STATE OF NORTH CAROLINA
DEPARTMENT OF TRANSPORTATION

Contract No.: DL00129
WBS No.: 17BP.12.R.13
Location: SR #2209
County: Gaston

RE: Addendum #1 to Contract DL00129.

STATE OF NORTH CAROLINA
 DEPARTMENT OF TRANSPORTATION
 RALEIGH
 DESIGN SERVICES LIGHTING & ELECTRICAL
ELECTRICAL CONDUIT SYSTEM
 WESLEYAN DRIVE (SR 2209)

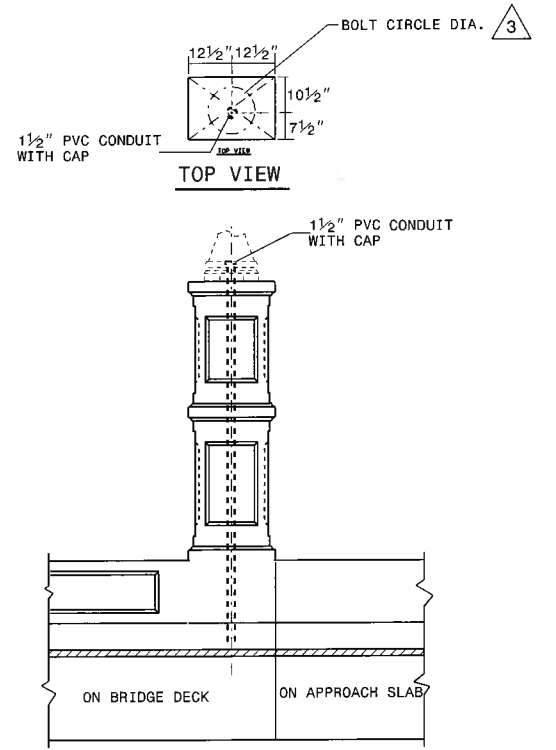
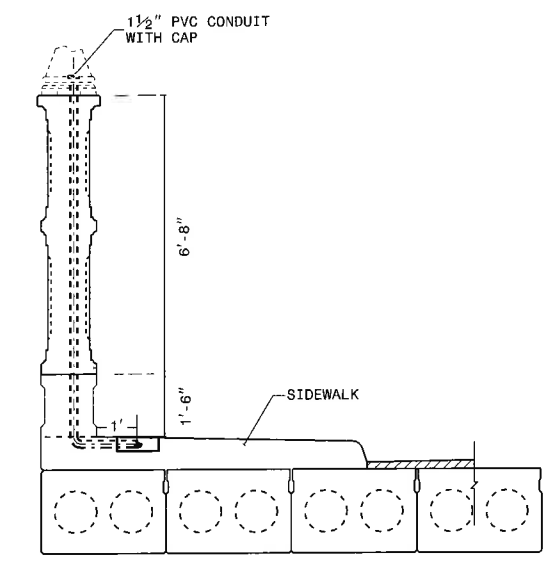
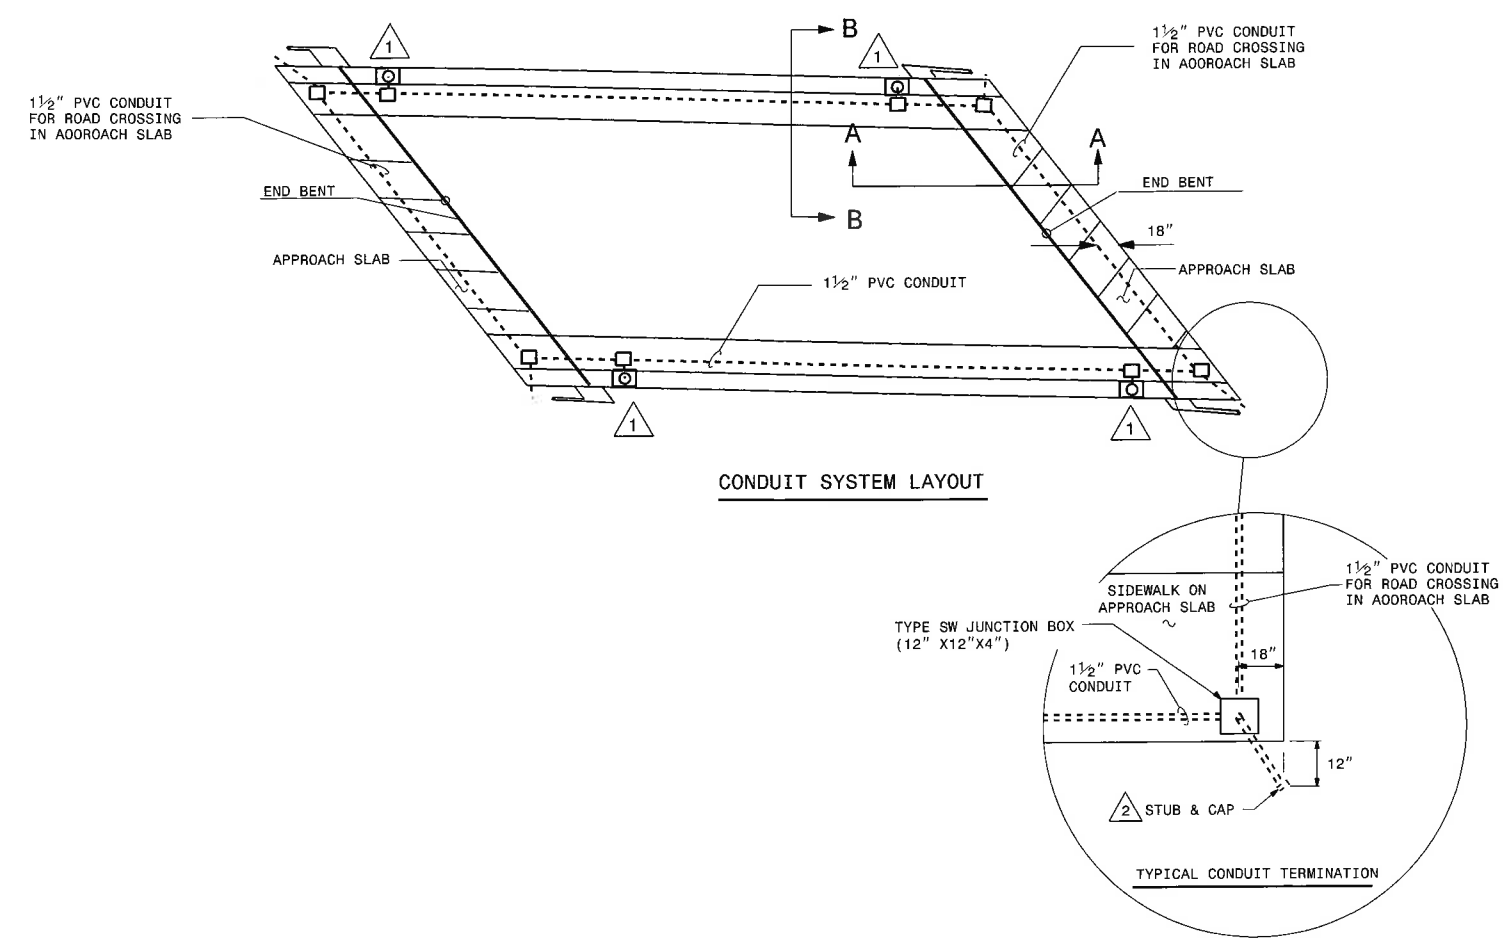
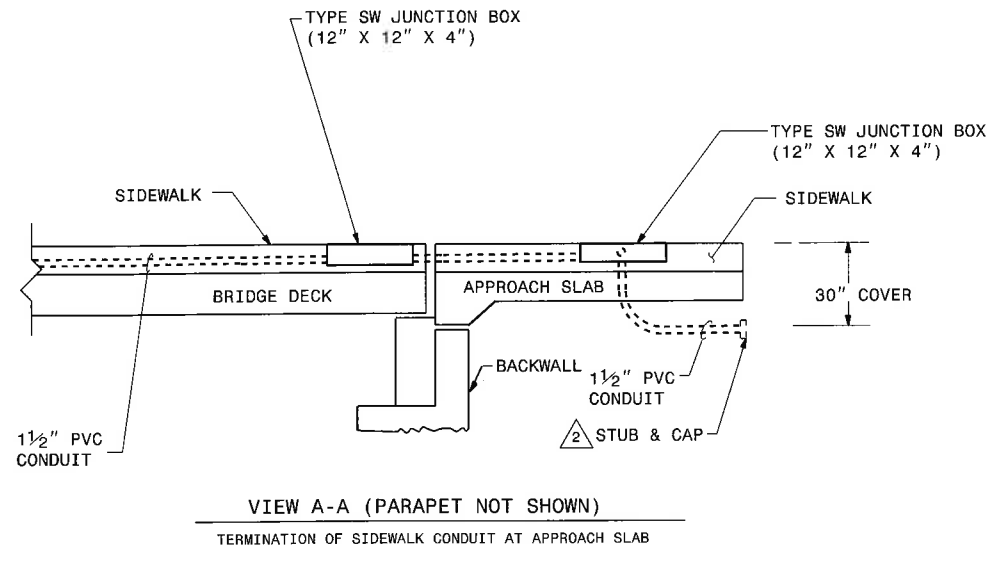
- Plan sheet ECS-1 has been added to clarify the pay item for "Electrical Conduit System at Station 13+40 -L-".

- All electrical and sewer work must be completed by a licensed contractor.
- Stub outs for the proposed electrical conduit system shall be located on the North West corner of the project (parcel 3). The electrical conduit plans contain standard details only and do not specify which corner the stub outs are to be located.

- According to the lighting unit with DOT, no expansion joints are required between the sidewalks on the bridge and the approach slabs but we have asked for a revised plan sheet or details for an expansion fitting to be used at these locations. All work for this pay item is lump sum and shall be considered full compensation for all electrical conduit, fittings, and wiring used for this work.
